ADDENDUM TWO

Addendum Two (AD.02) to the drawings and specifications prepared by Gibraltar Design for **Godare Hall Renovations** for Vincennes University, Vincennes, Indiana.

RE **Pre-Bid Meeting - Question and Answer**
Vincennes University – **Godare Hall Renovations**
Vincennes, IN
Gibraltar Design Project No: 26-115

1 S-101 FIRST FLOOR STRUCTURAL PLAN - NORTH
SCALE: 1/8" = 1'-0"

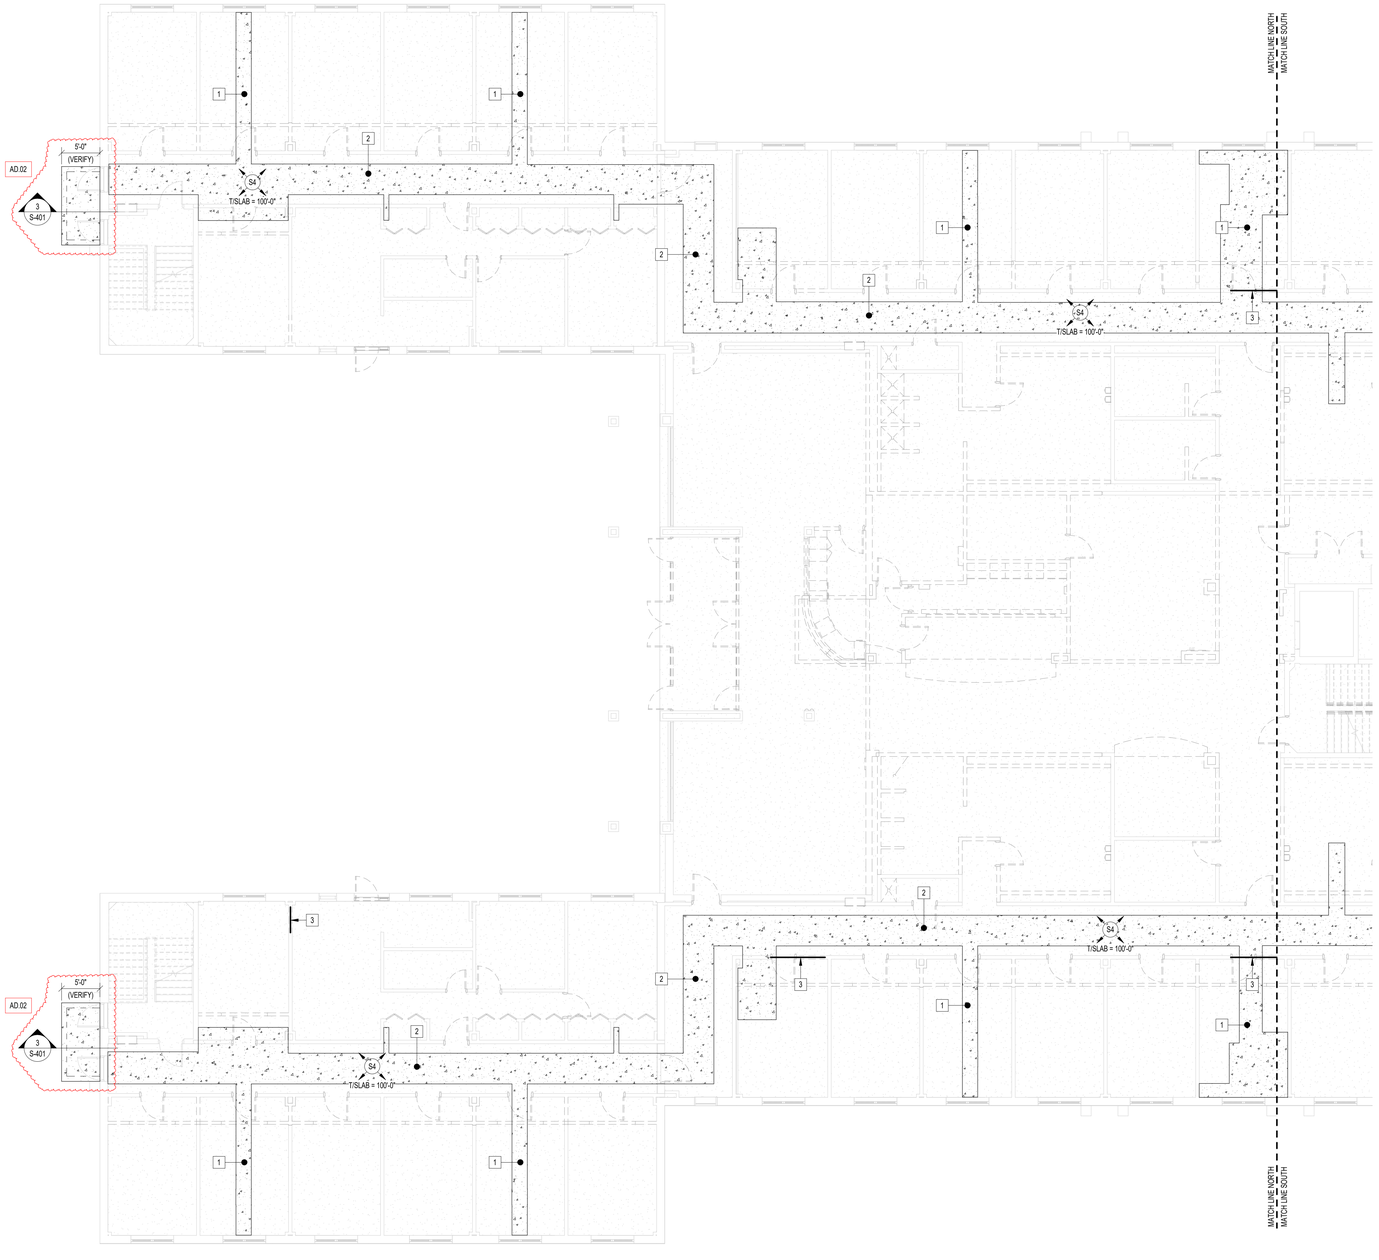
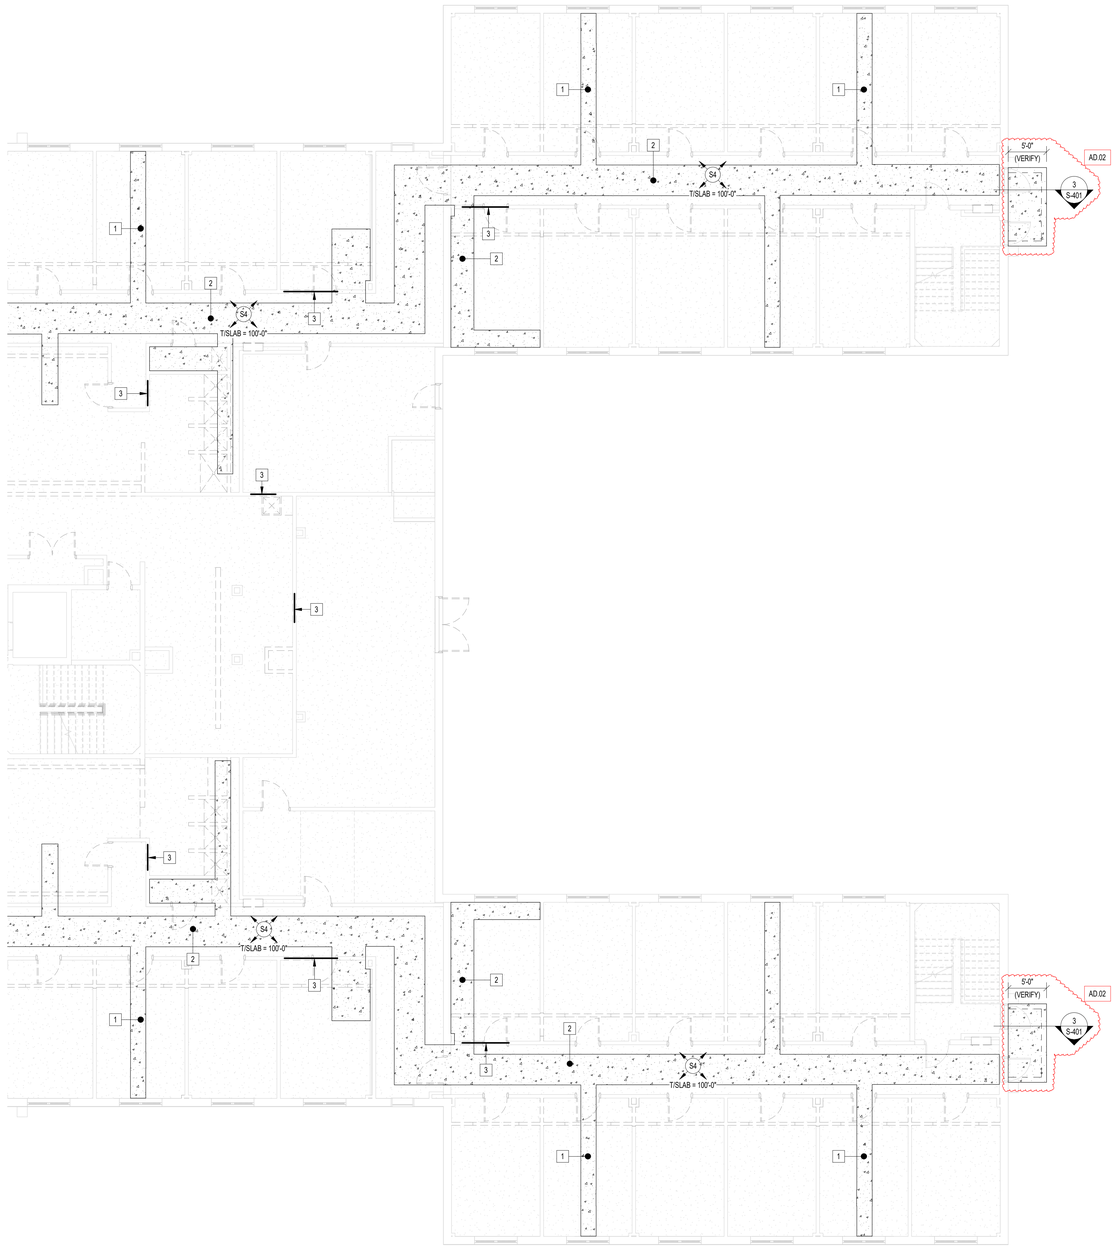
1. Void slab added at each wing

1 A-410 **ENLARGED STAIR AND ELEVATOR PLAN**

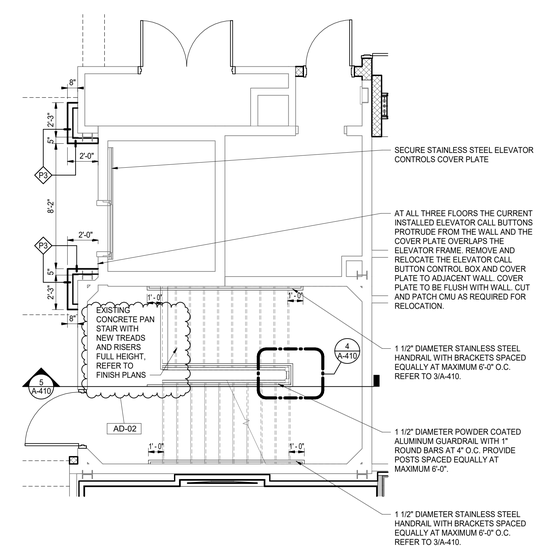
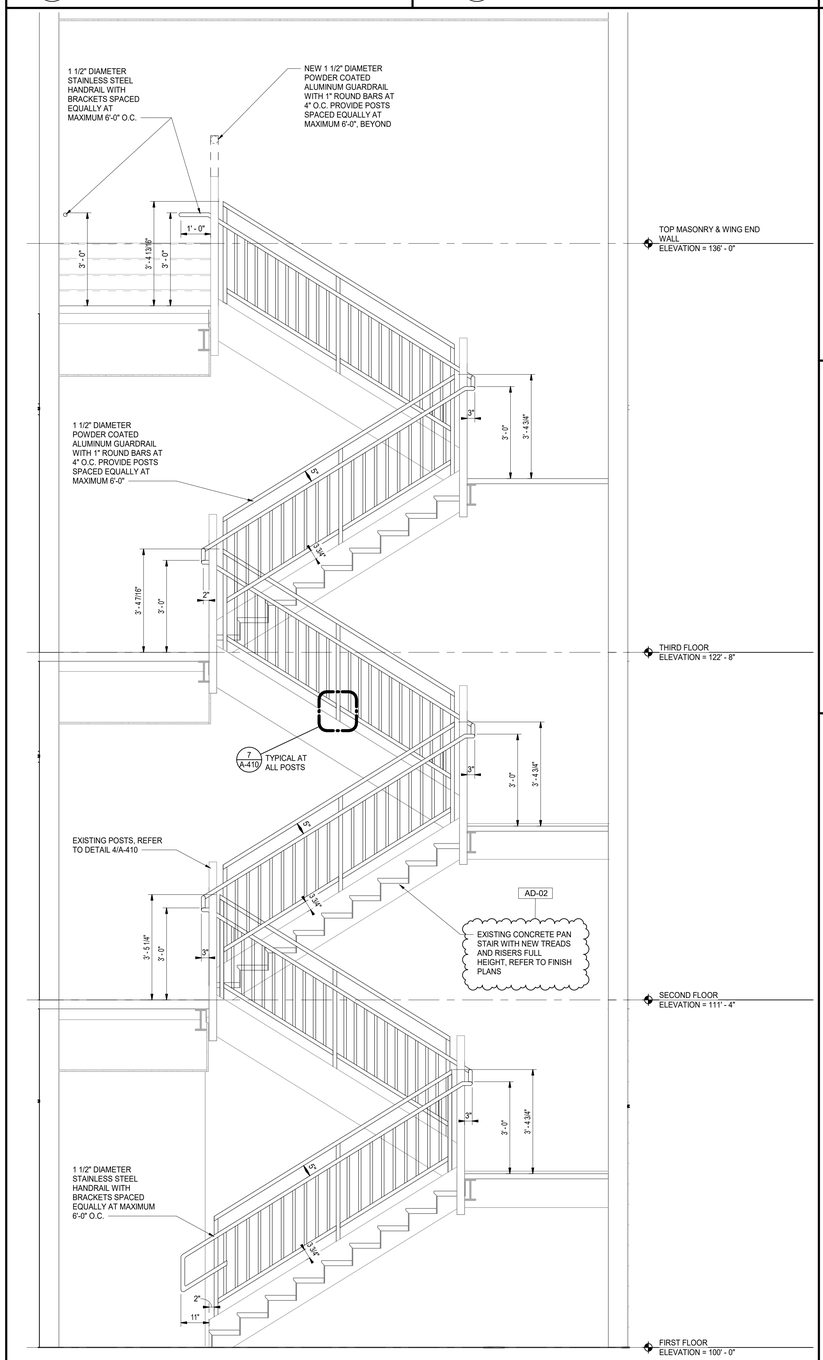
18. Sheet A-410

A. Refer to revised, full-size drawing, included in this Addendum, for revisions.

1 A-412 **ENLARGED SCREEN WALL PLAN**

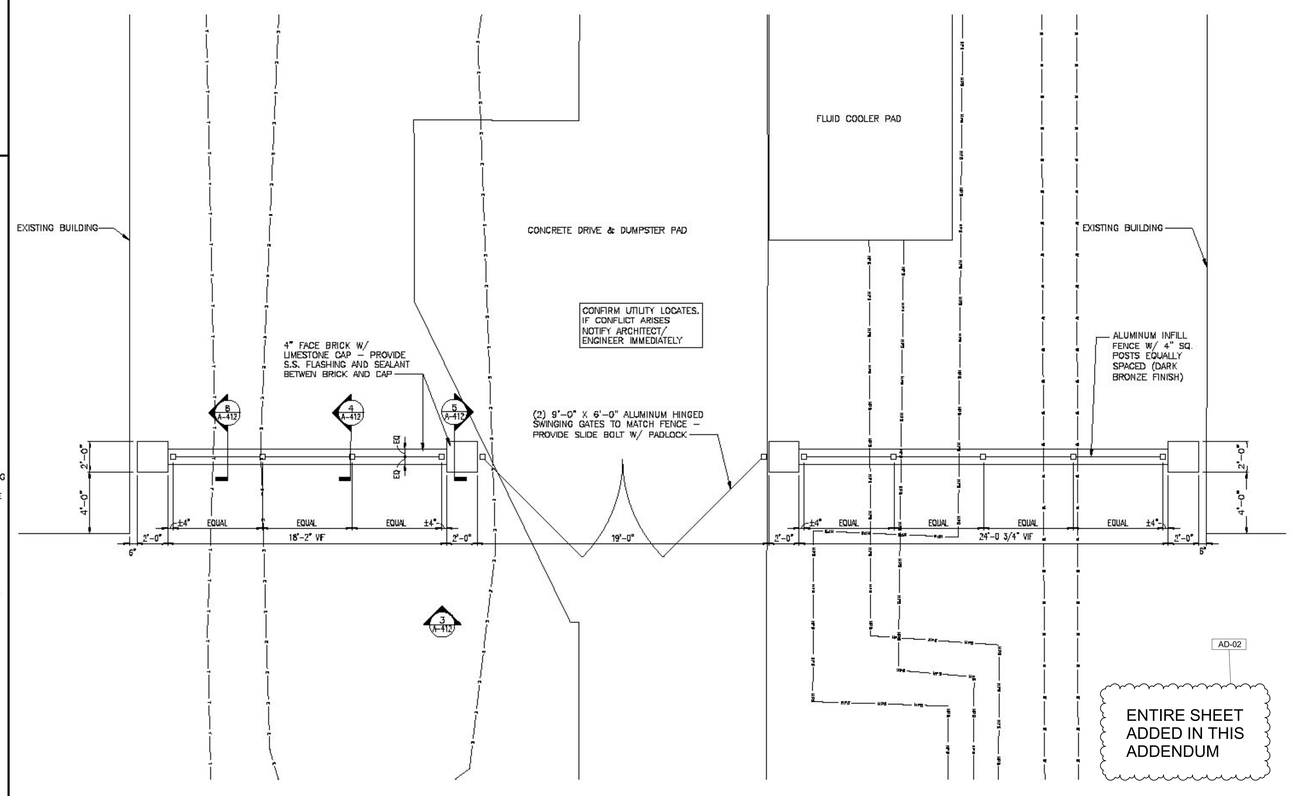
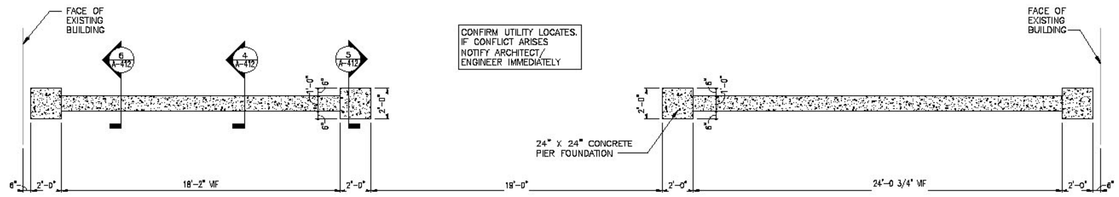
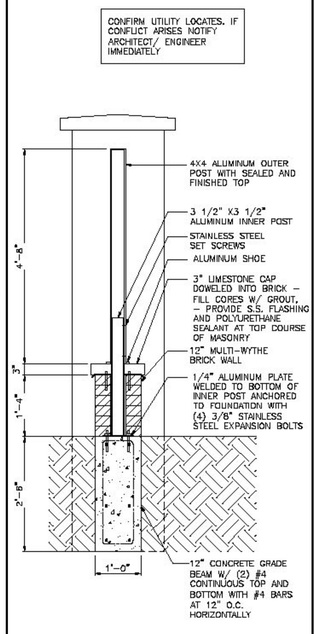
B. Add Paragraph 3.3.J. to read as follows: "J. Aluminum Fence System: Alternate #5 Bid Scope of work for Mechanical yard Screen Wall Enclosure."

19. Sheet A-412

"2.4 Aluminum Fence System: (Alternate Bid #5)

A. Aluminum Posts: HSS 4-inch x 4-inch x 1/4-inch.

B. Aluminum Bottom Rail: HSS 4-inch x 2-inch x 1/4-inch.

C. Aluminum Louver panel system spanning horizontally, refer to drawings for sizes, framed with aluminum angles on both ends and bolting these angles into vertical aluminum posts.

D. Aluminum Mesh Fencing top section – spanning vertically. And framed into aluminum angle frame

E. Anchor supports, either stainless steel or aluminum – refer to drawings.

F. Aluminum Sleeve for setting into masonry and extending up sufficiently to support aluminum posts – refer to drawings.

G. Aluminum Escutcheons for closure of posts to stone cap.".

A. Add new, full-size drawing, included in this Addendum, to project documents.

6 A-610 **ALUMINUM STOREFRONTELEVATIONS (SF)**
SCALE: 1/4" = 1'-0"

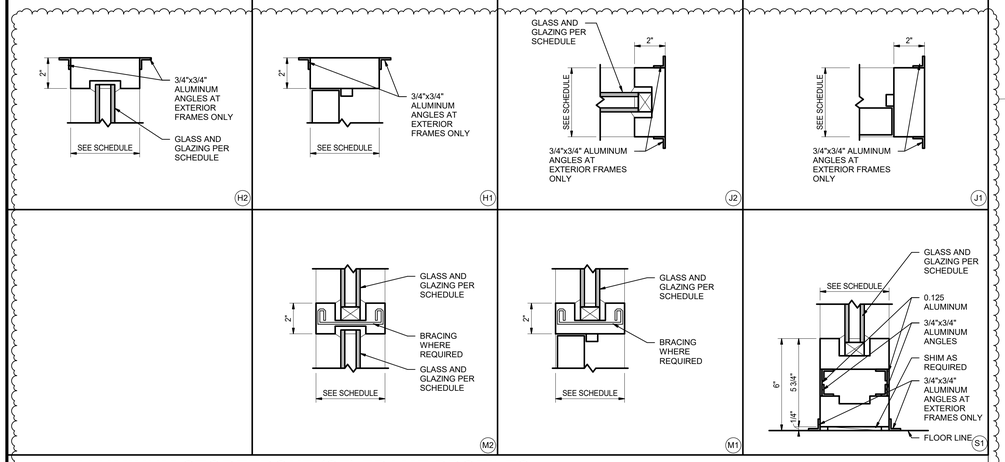
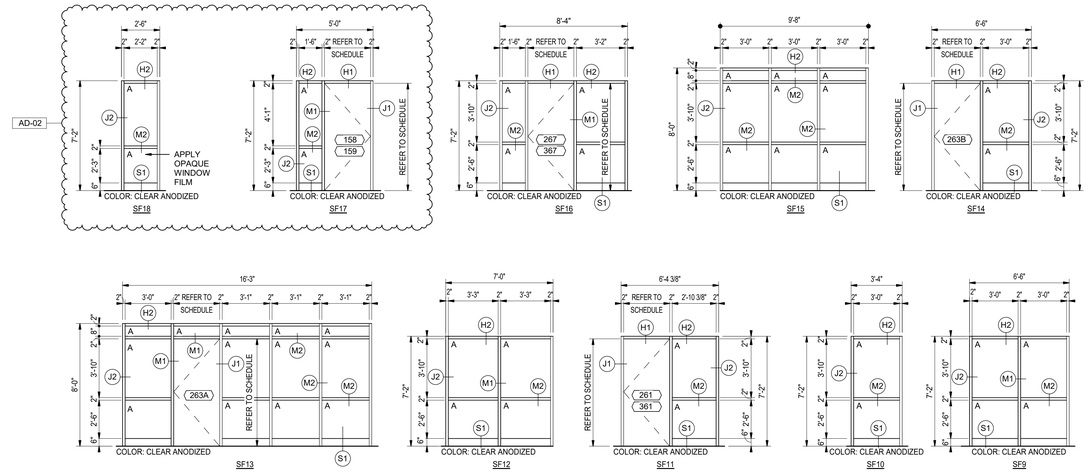
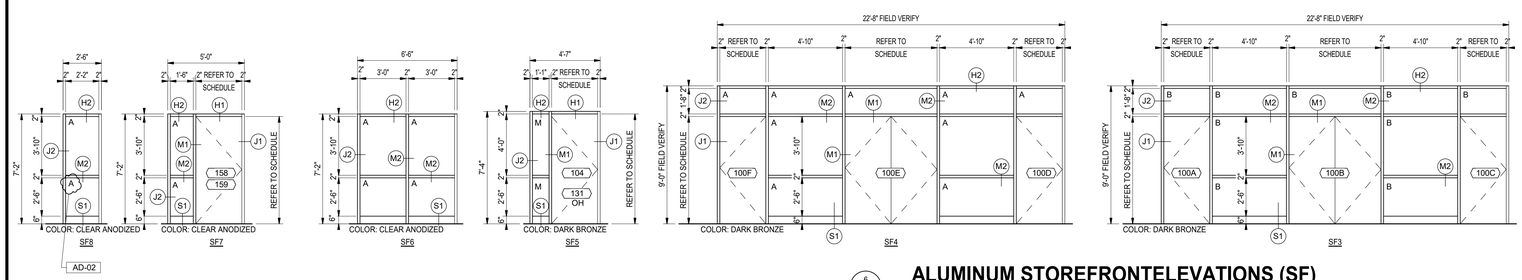
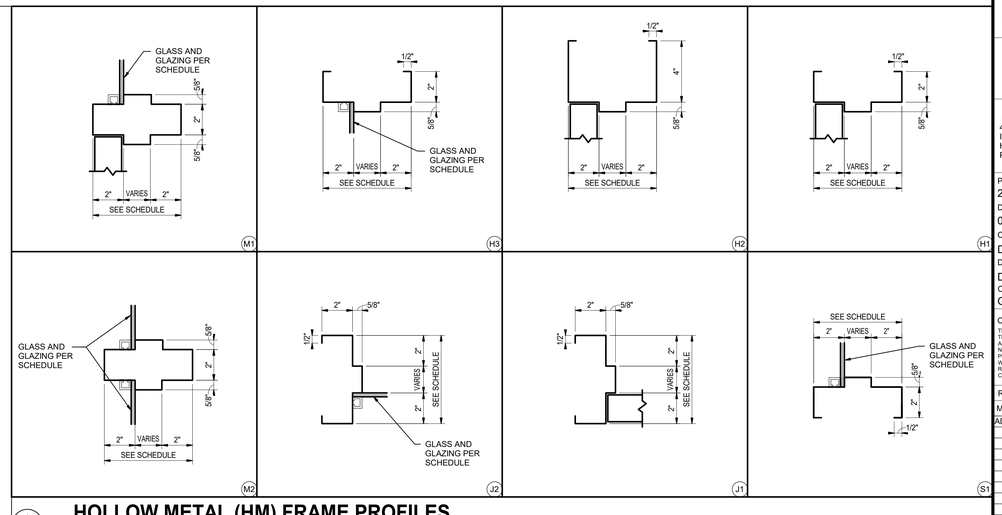
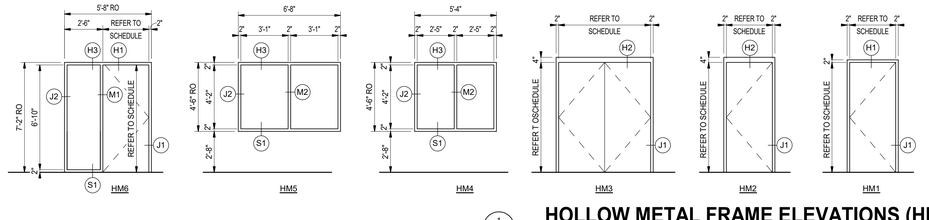
22. Sheet A-610

A. Refer to revised, full-size drawing, included in this Addendum, for revisions.
